**Addendum No:** 002  
**Date Issued:** 03 September  
2024  
**Project Number** 12303  
**Bid Number** T2024-220

**Project** **City of Brampton Fire Station 215**  
10539 Goreway Drive, Brampton.

**Addendum No.:** 02

DRAWING  
**GARBAGE ENCLOSURE**

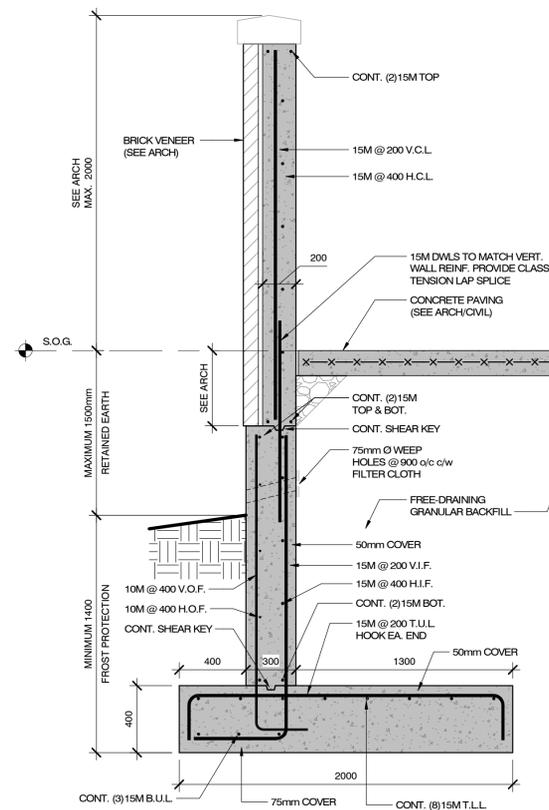
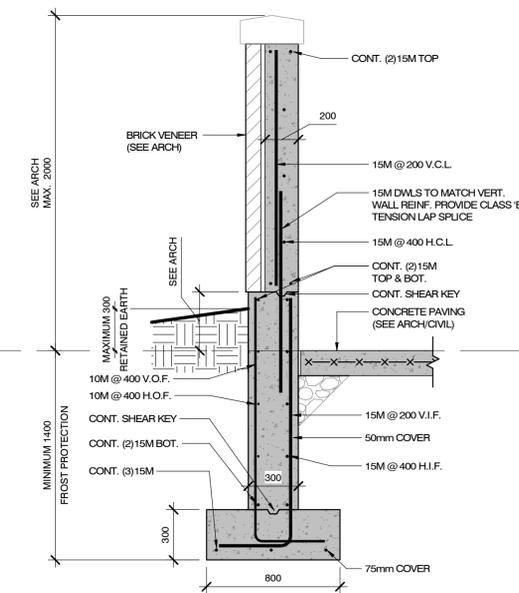
Item 1	Garbage Enclosure
S1.0	1. Remove retaining walls from first row of Concrete Mix Properties Table. 2. Add row for Retaining Walls & Retaining Wall Footings to Concrete Mix Properties Table.
S8.0	1. Add sheet S8.0 Garbage Enclosure. 2. Add reinforced concrete garbage enclosure plan and section details.

### LEVEL 01 PLAN - VENTILATION

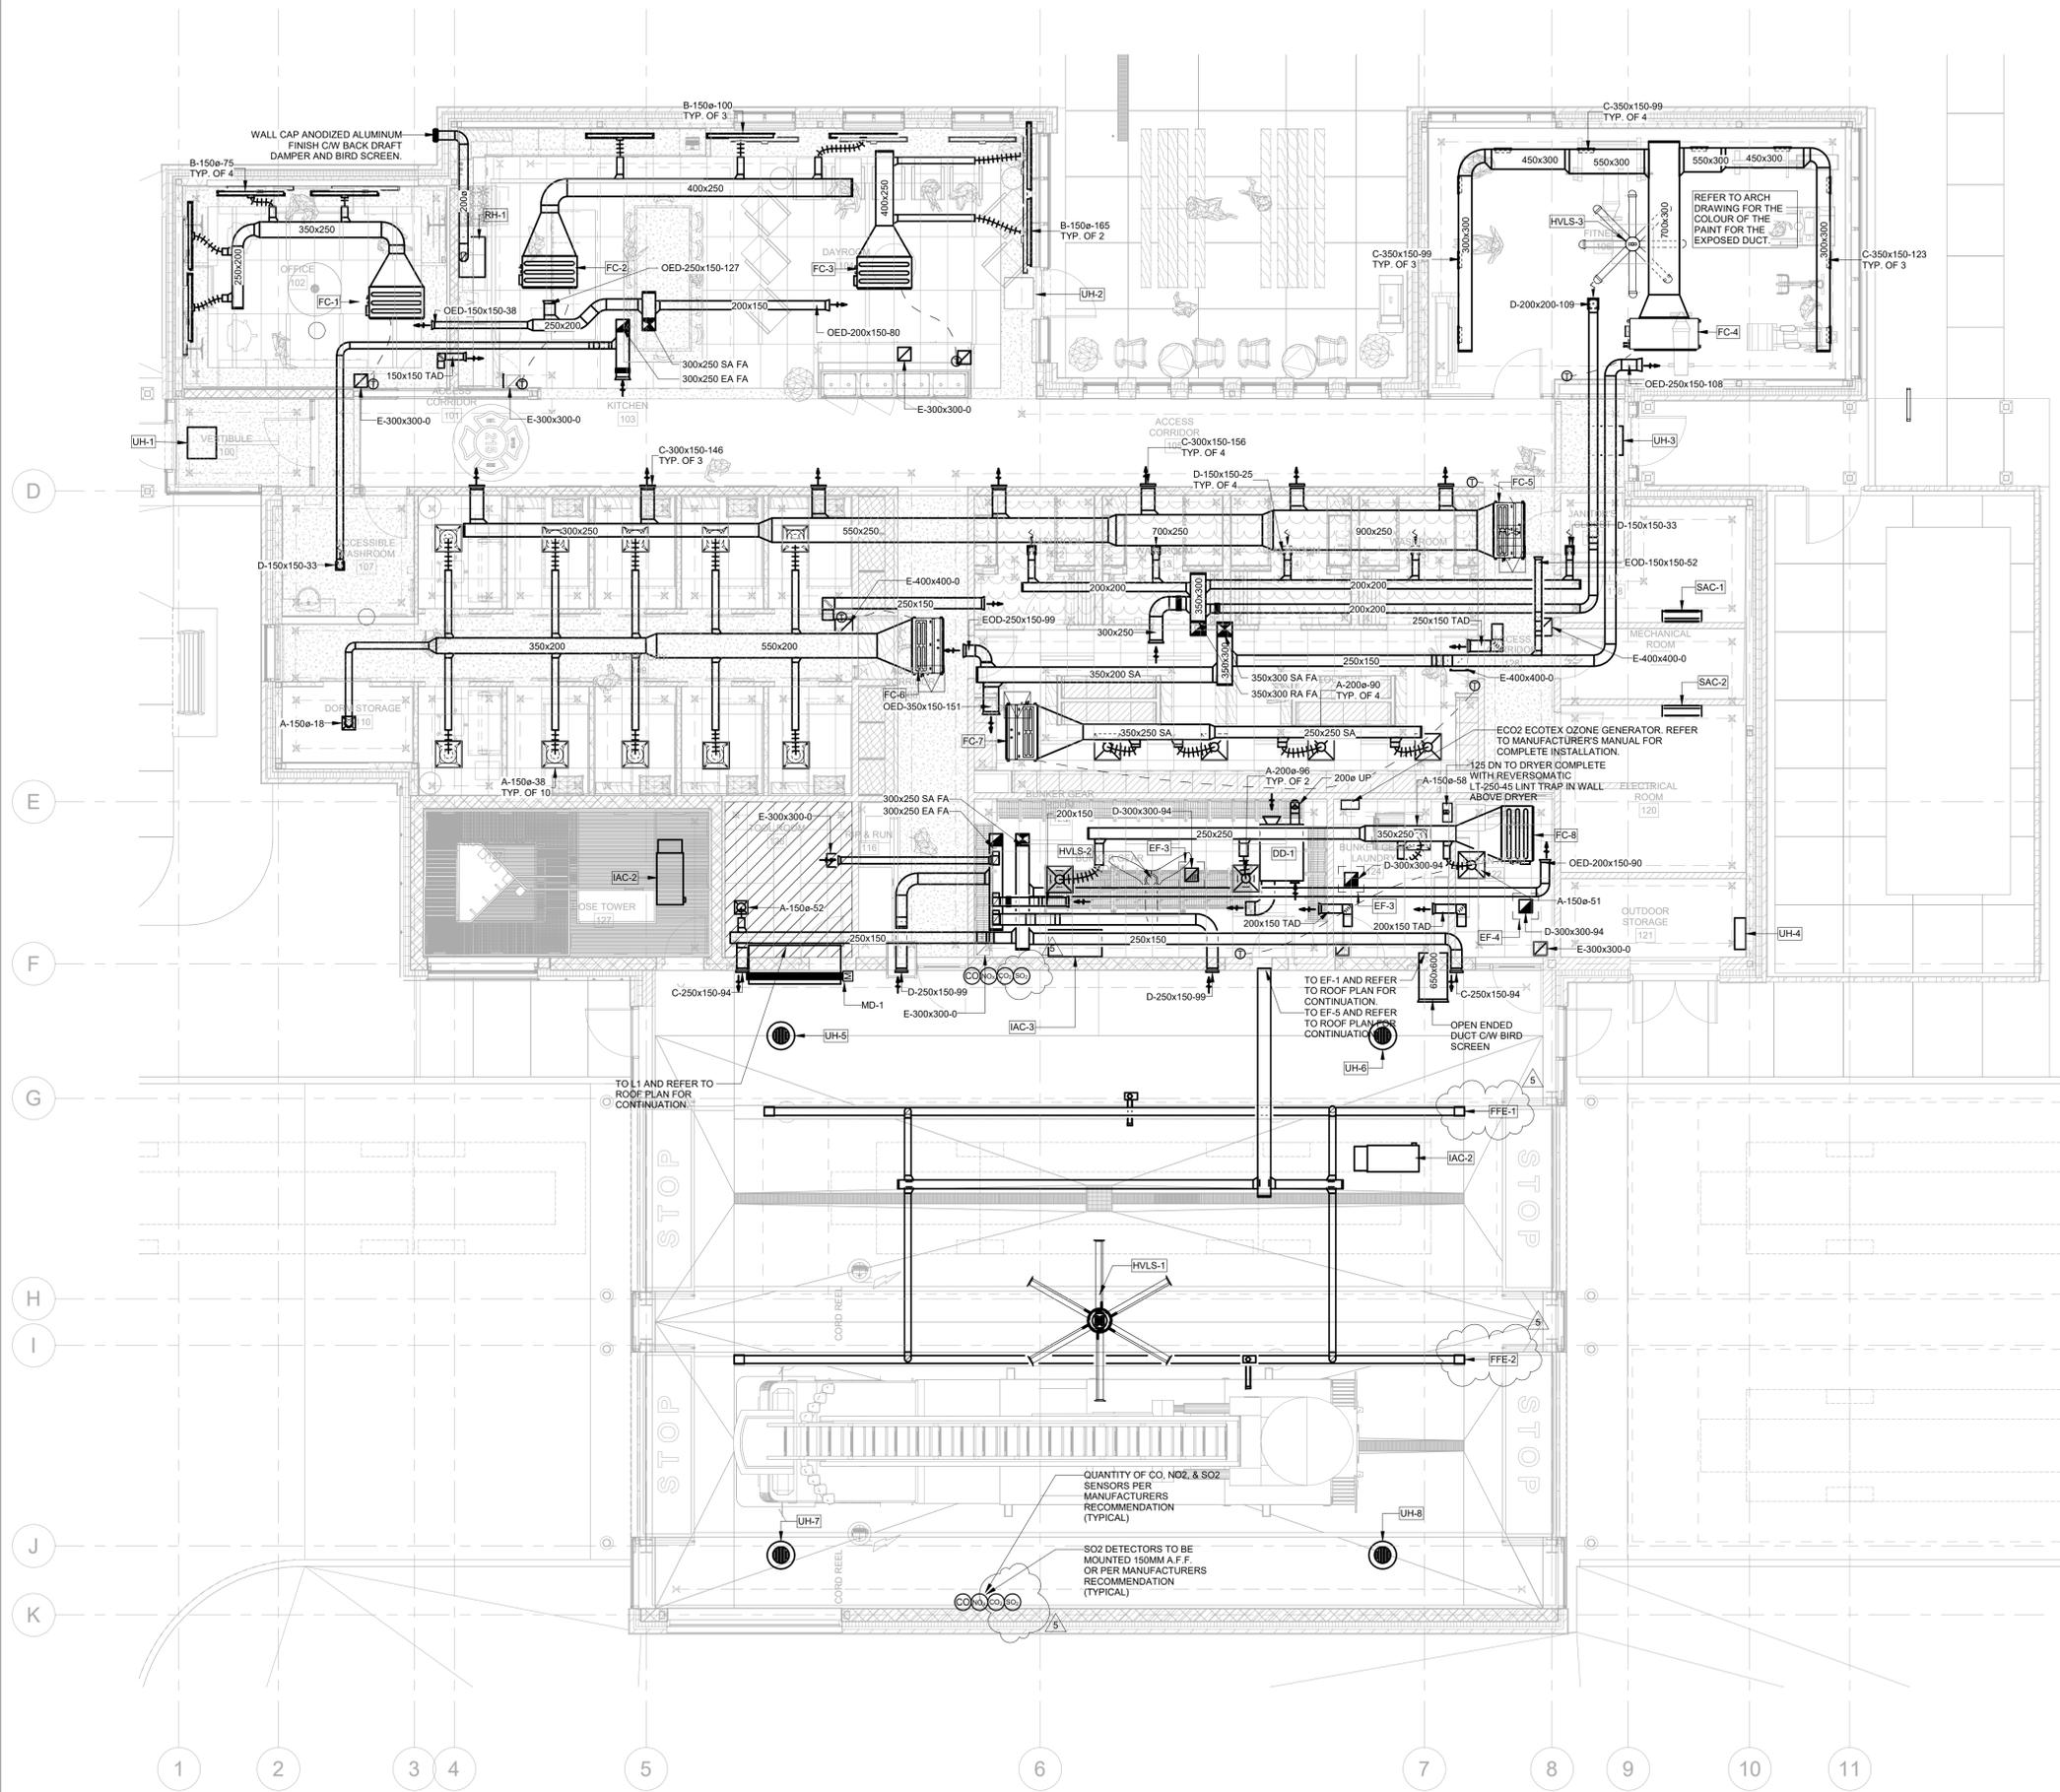
- .1 **Drawing M-301 – LEVEL 01 PLAN - VENTILATION**
  - i) Added tagging for exhaust tail pipe guide rail.
  - ii) Added symbol for SO2
- .2 **Drawing M-751– MECHANICAL CONTROL SEQUENCES I**
  - i) Updated apparatus bay fan control sequence
  - ii) Updated ceiling mounted destratification fan(HVLS) control sequence
- .3 **Drawing M-753– MECHANICAL CONTROL SEQUENCES III**
  - i) Added domestic hot water tank control sequence
- .4 **Drawing M-754– MECHANICAL CONTROL SEQUENCES IV**
  - i) Added VRF fan coil unit control sequence
  - ii) Added energy recovery ventilators control sequence
  - iii) Added desiccant dehumidifier control sequence
  - iv) Added kitchen exhaust fan control sequence
- .5 **Drawing M-755– MECHANICAL CONTROL SEQUENCES V**
  - i) Added Exhaust Fan (EF-2, EF-3, EF-4 & EF-6) control sequence
  - ii) Added DX fan coil unit control sequence

**ELECTRICAL SITE PLAN**

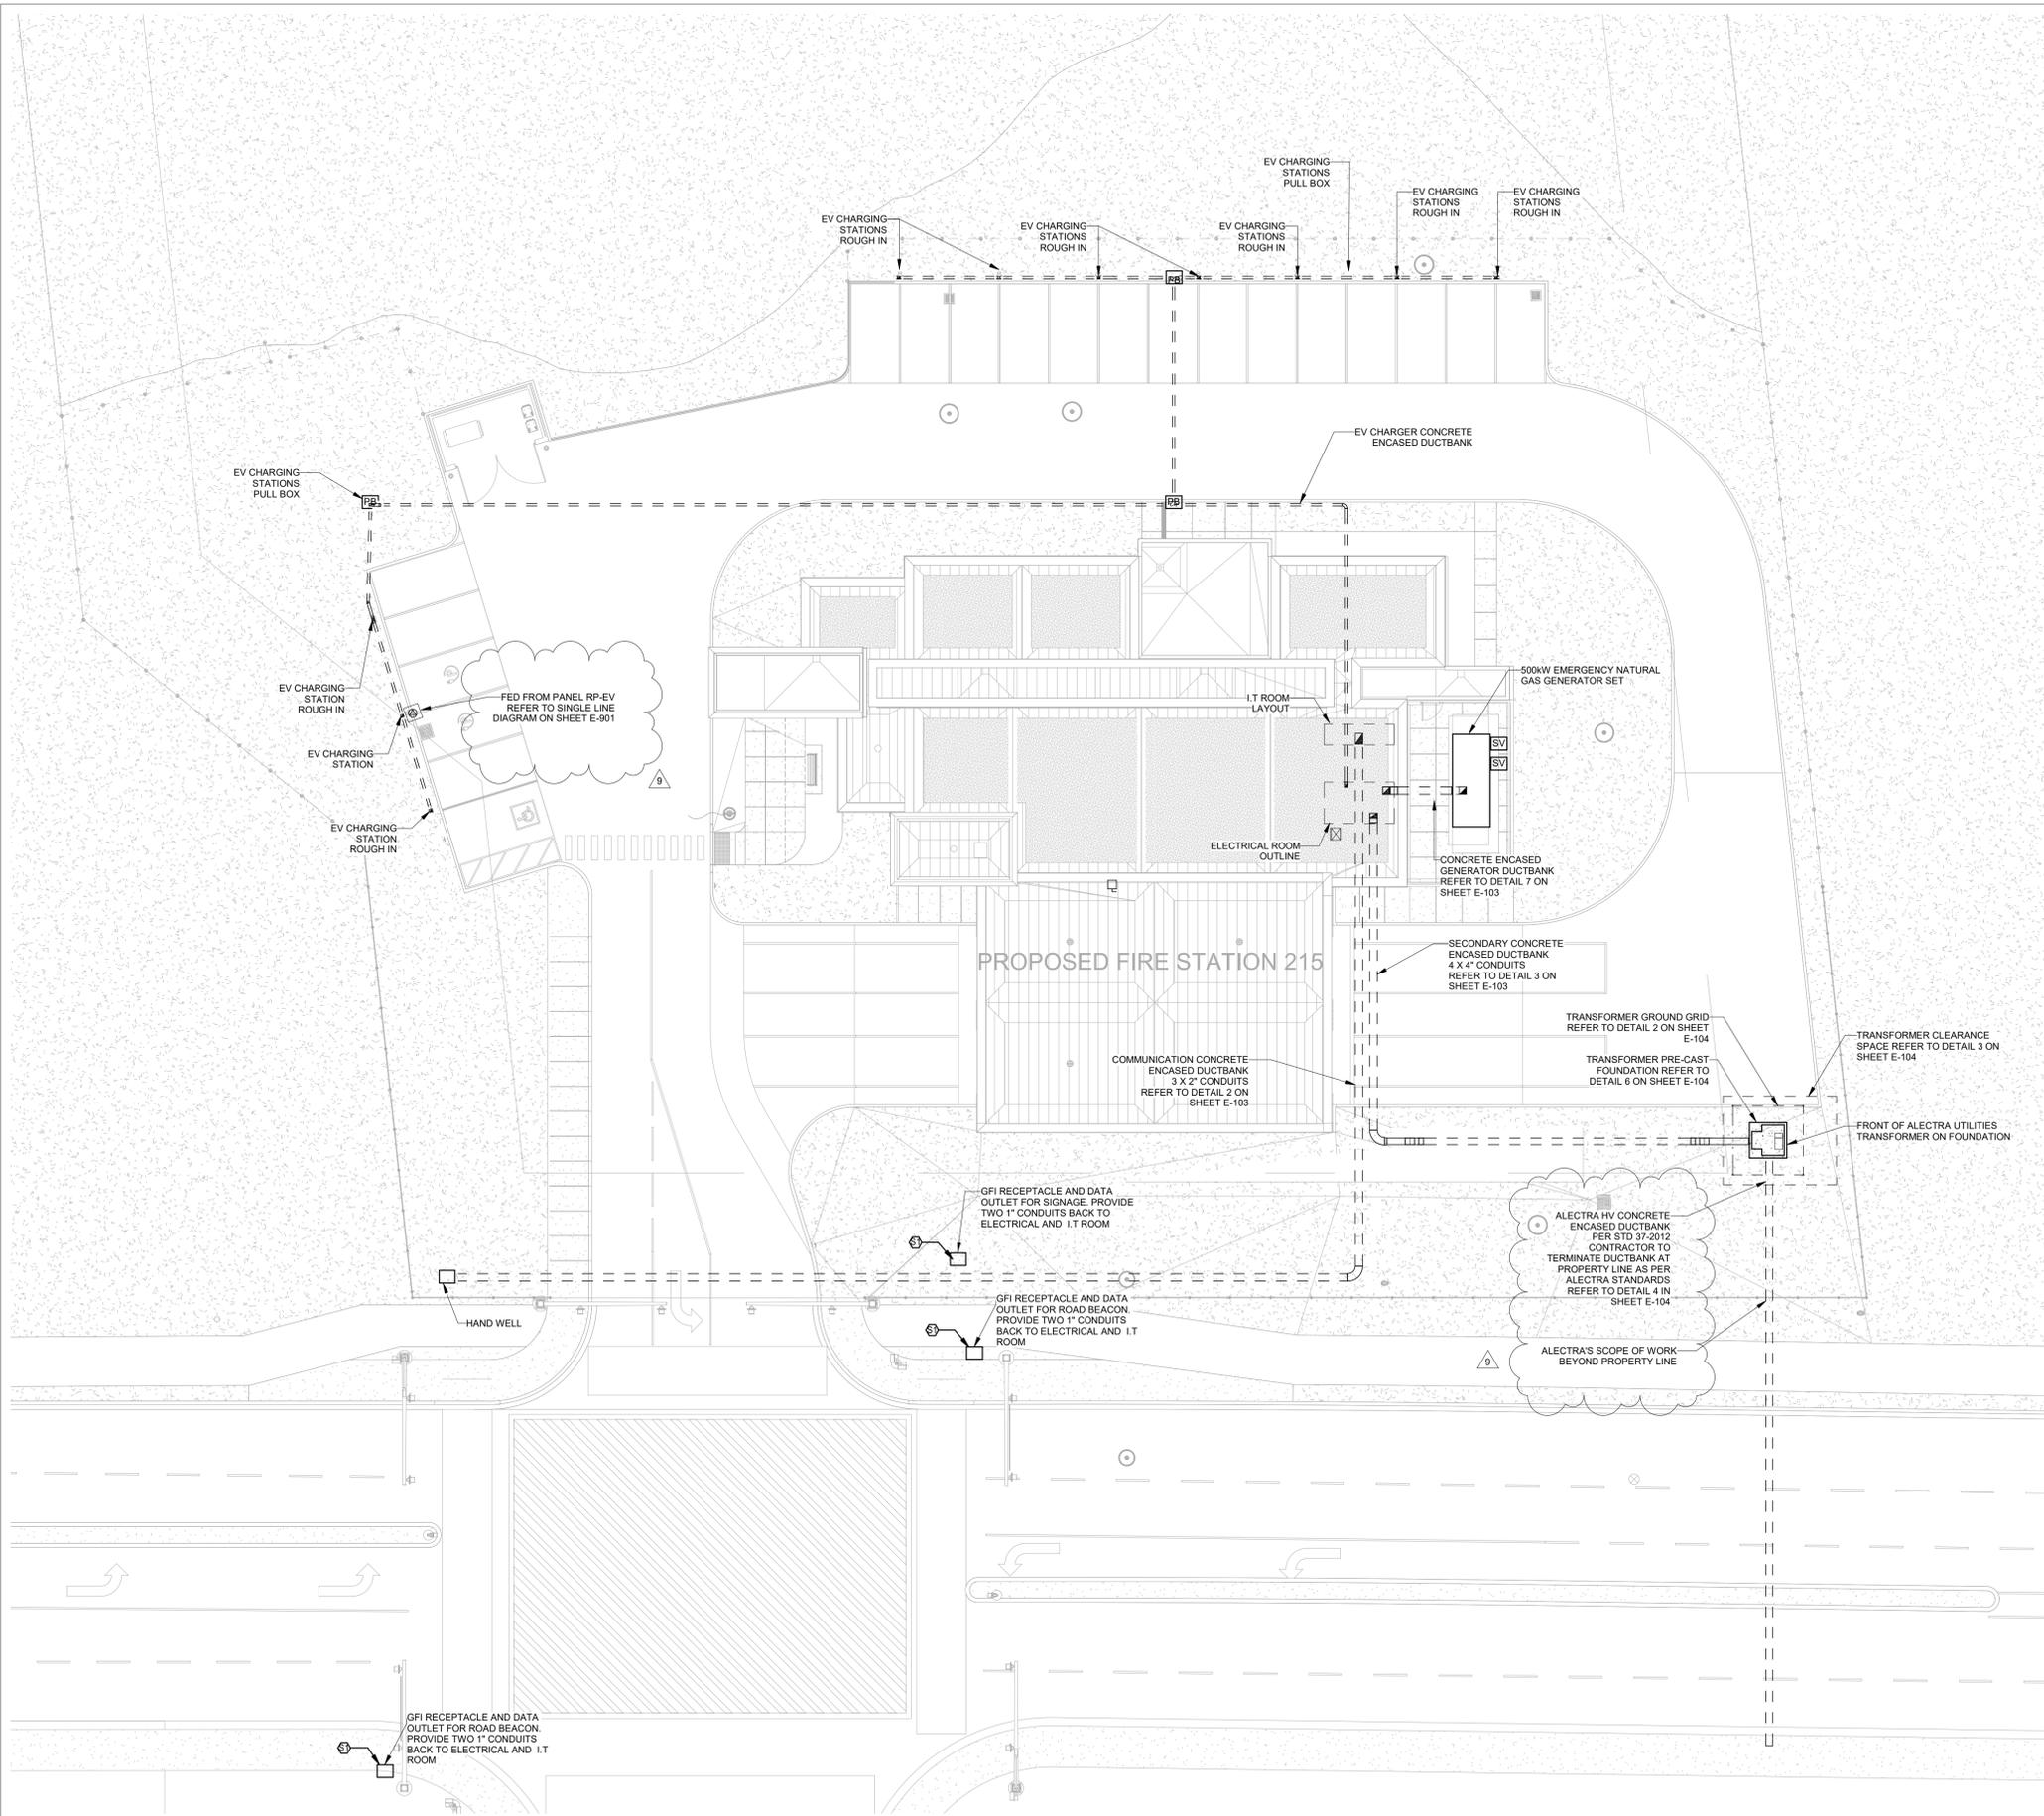
- .1 Drawing E-001 – ELECTRICAL LEGENDS AND GENERAL NOTES**
  - i) Refer to drawing revisions.
- .2 Drawing E-002 – ELECTRICAL SITE PLAN**
  - i) Refer to drawing revisions.
  - ii) EV Charging station notes were revised.
  - iii) Primary Duct Bank detail notes revised.
  - iv) Added note keynote S1.
- .3 Drawing E-003 – ELECTRICAL SITE LIGHTING PLAN**
  - i) Refer to drawing revisions.
  - ii) Pole mounted security camera note revised.
- .4 Drawing E-103 – ELECTRICAL SITE PLAN DETAILS**
  - i) Refer to drawing revisions.
  - ii) Detail 3 Ampacity values added.
- .5 Drawing E-201 – LEVEL 01 PLAN - LIGHTING**
  - i) Refer to drawing revisions.
  - ii) An exit sign circuit was added to the drawings.
- .6 Drawing E-202 – LEVEL 01 PLAN – POWER & SYSTEMS**
  - i) Refer to drawing revisions.
  - ii) Add 100A,3P Disconnect switch for EV Fire truck feed.
  - iii) 100A Coord reel note revised.

### ROOF PLAN - POWER & SYSTEMS

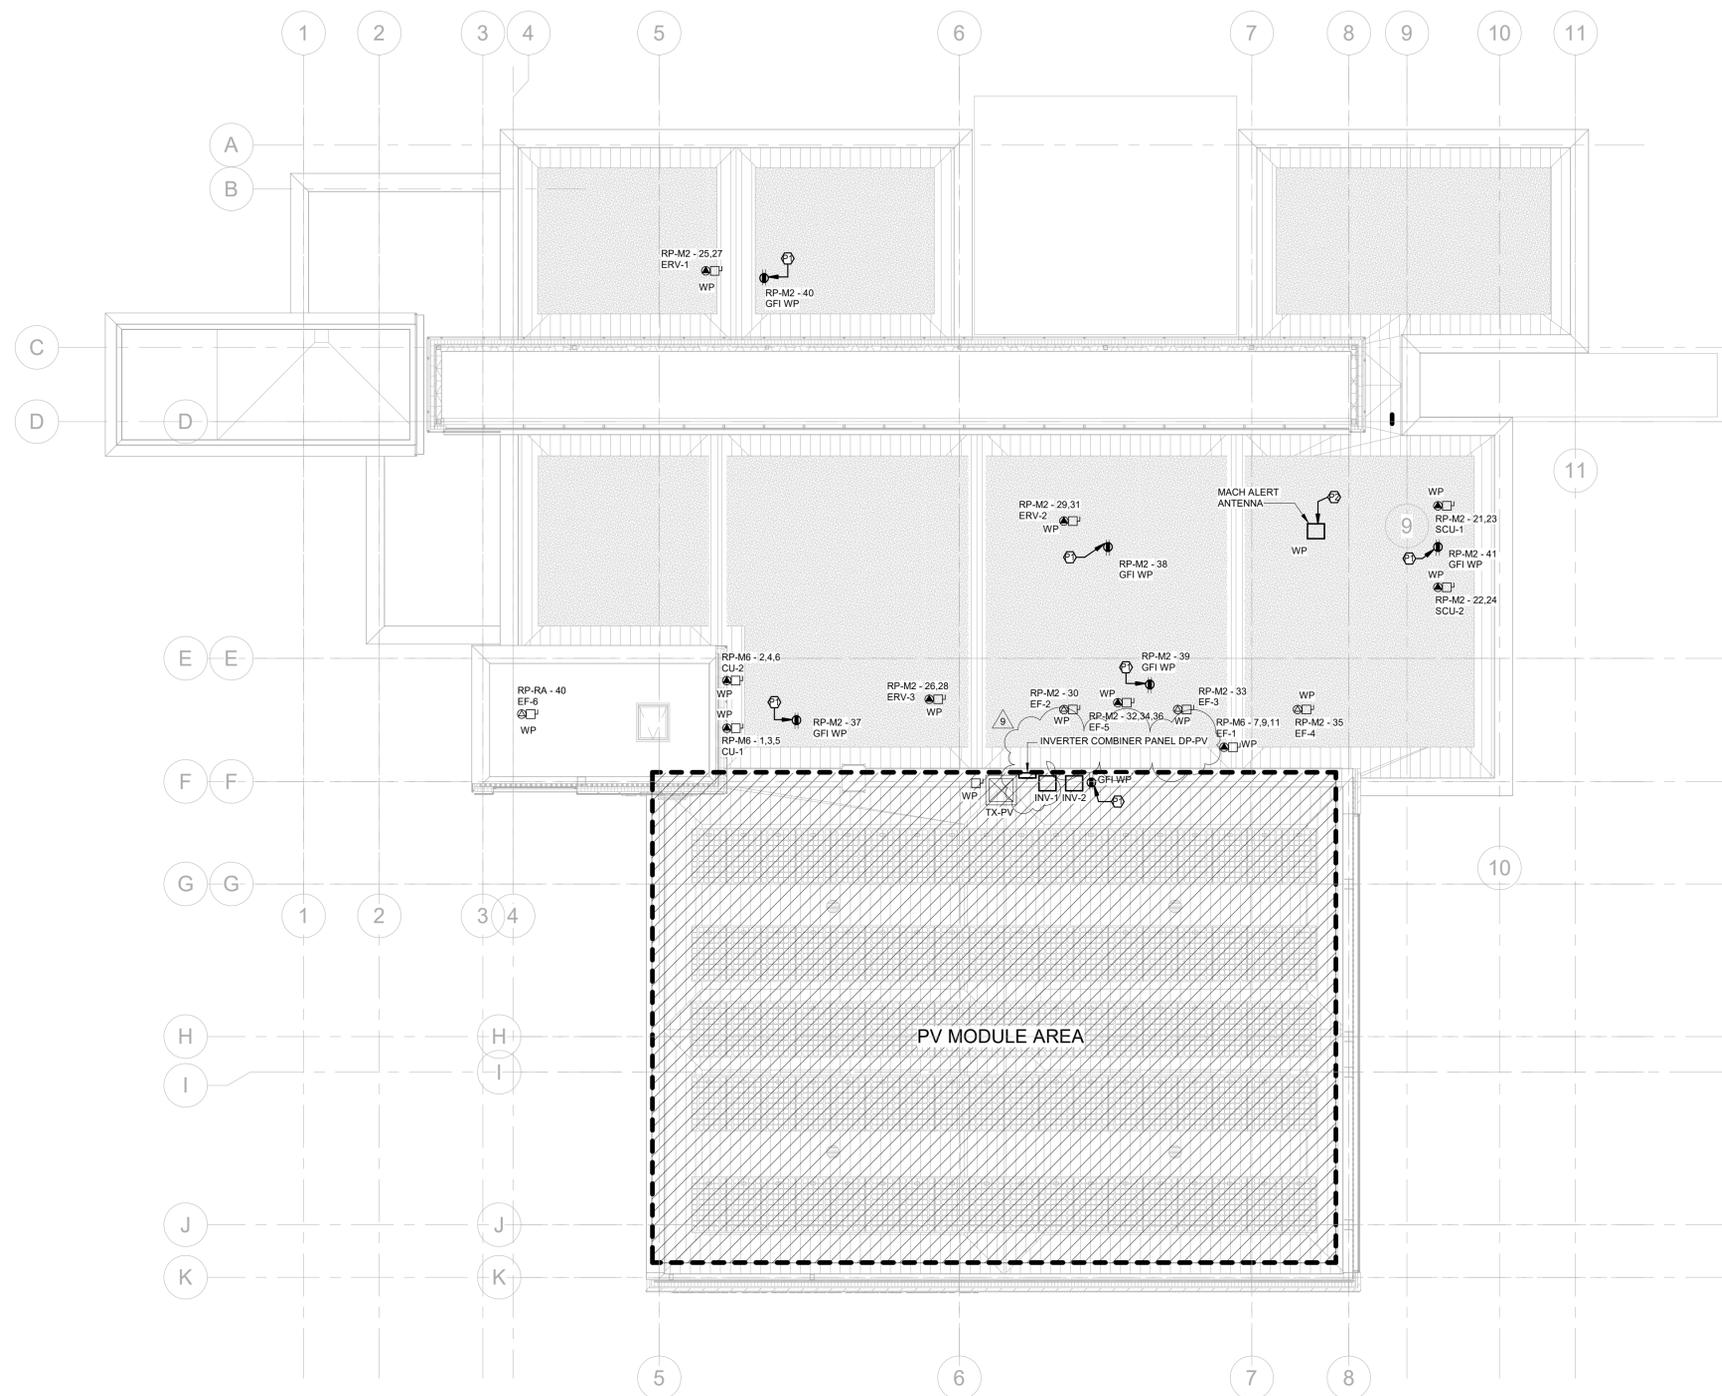
- iv) Add transformer TX-UEV2 in electrical room.
- .7 Drawing E-302 – ROOF PLAN – POWER & SYSTEMS**
  - i) Refer to drawing revisions.
  - ii) Add tag to inverter combiner panel DP-PV.
